**Technical Service Bulletin (TSB)**  
**RSU With Additional Sleep Cycles for HV Battery Integrity Check**  
**- Flash: Electronic Vehicle Control Unit (EVCU) Updates 6A1**

<b>REFERENCE:</b>	<b>TSB:</b> 08-073-25 REV. A <b>GROUP:</b> 08 - Electrical	<b>Date:</b>	April 29, 2025	<b>REVISION:</b>	08-073-25
<b>VEHICLES AFFECTED:</b>	<b>2025 (LB) Dodge Charger</b> This bulletin applies to vehicles <b>**built on or before April 03, 2025**</b> equipped with 400V G2500 FR/RR Elec Drive Motors (Sales Code ELD).	<b>MARKET APPLICABILITY:</b>			
		<input checked="" type="checkbox"/> NA <input checked="" type="checkbox"/> MEA <input checked="" type="checkbox"/> SA <input checked="" type="checkbox"/> IAP <input checked="" type="checkbox"/> EE <input checked="" type="checkbox"/> CH			
<b>CUSTOMER SYMPTOM:</b>	<p><b>Customers may experience a Malfunction Indicator Lamp (MIL) illumination and the vehicle may exhibit/set one or more of the following Diagnostic Trouble Codes (DTCs):</b></p> <ul style="list-style-type: none"> <li>• C10F8-00 - Left Front Wheel Hub Disconnect Actuator Position Sensor Circuit Range/Performance.</li> <li>• C10F9-00 - Right Front Wheel Hub Disconnect Actuator Position Sen

**Fig. 3**  
#38 AGSM Fuse Location

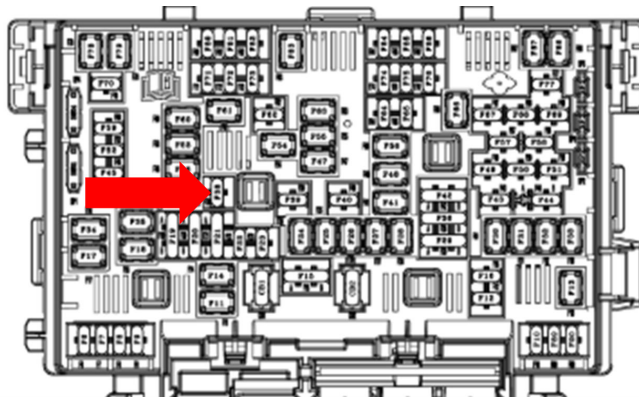
6. Remove the PDC cover, locate and remove the #38 AGSM fuse [Fig. 3](#).\*\*

24. \*\*Install the #38 AGSM fuse [Fig. 3](#) and the PDC cover [Fig. 2](#).
